The Proposed Extinguishment of Penleigh Park Level Crossing, Footpath Westbury 15.

Network Rail Response to Objections.

Subject: The Proposed Extinguishment of Penleigh Park Level Crossing, Footpath Westbury 15

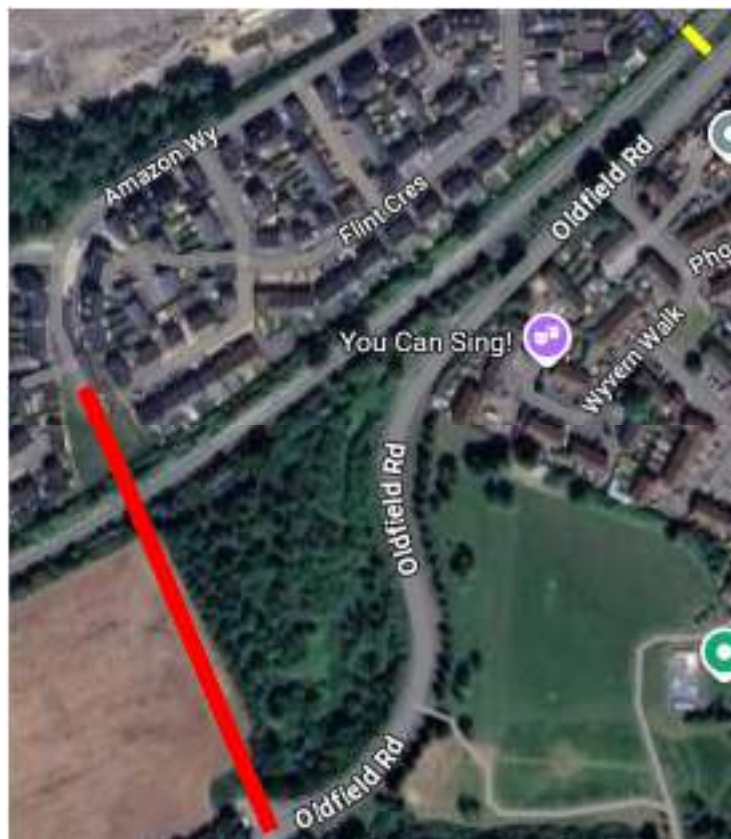
Concerns have been raised regarding the promise of a bridge during the consultation and consideration of the development which has occurred adjacent to the Penleigh Park level crossing.

The Council's aspiration at the time was to build a new road bridge across the railway to connect Mane Way to Amazon Way, shown in red below with the crossing in yellow, whereas Network Rail were more concerned about the impact the development would have on level crossing usage and were comfortable should a footbridge be constructed at the

location of the level crossing, location shown in yellow below, this would overcome our safety concerns. Through the planning process and as a requirement of the planning permission for 300 houses in 2016 a £2 million contribution towards the cost of the bridge was required from the developer through a Section 106 agreement.

Due to Network Rail's concerns that the road bridge may not be delivered as a result of the remaining funding not coming forward or a change of political view on the delivery of the road bridge we requested a change to the S.106 with the default position should the council not build the road bridge within 10 years after the completion of the housing the £2 million developer contribution will come to Network Rail towards the cost of building a footbridge to facilitate the closure of the LC. Network Rail did ask for a much shorter period than 10 years in S.106 negotiation's albeit this was the timeframe accepted by the council as they were confident that a road bridge would be delivered much quicker than this.

Network Rail welcomes the support from the public and other stakeholders making representations to this extinguishment for the proposed bridge solution and agree that it represents a practical solution to enable the closure of the crossing. That's why we've supported the bridge proposal and recognise its potential to significantly reduce risk at this location. However, whilst Network Rail has continued to push for a delivery date this simply has not progressed and does not seem to have made any progress forward closer to construction. In addition, as the S.106 linked to the new housing only required a £2 million contribution should the funding now come to Network Rail a new footbridge would cost significantly more than this to deliver.

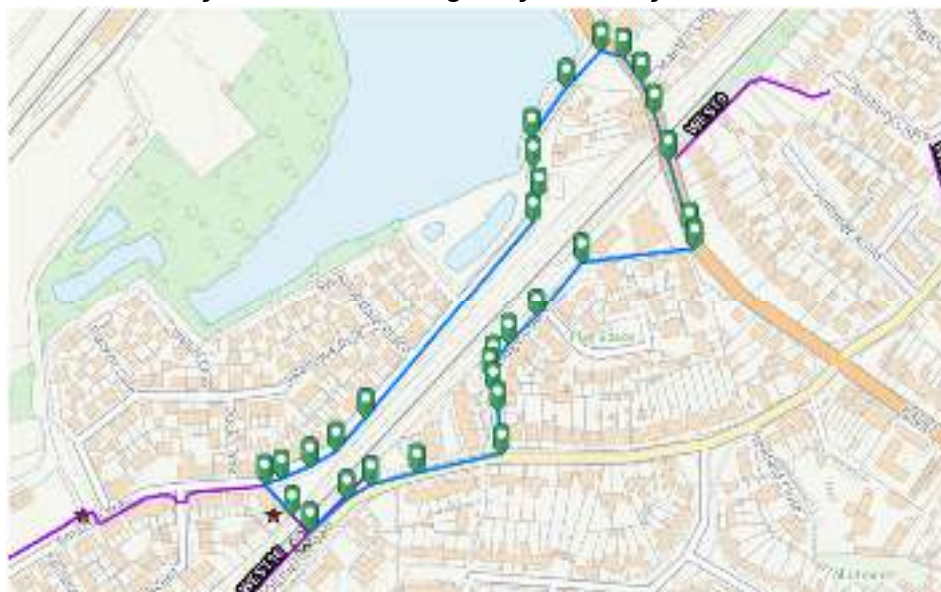
However, although some incidents / misuse goes down as reported there are also occasions of non-reported incidents which are caught on the permanent camera at the crossing, Images below:
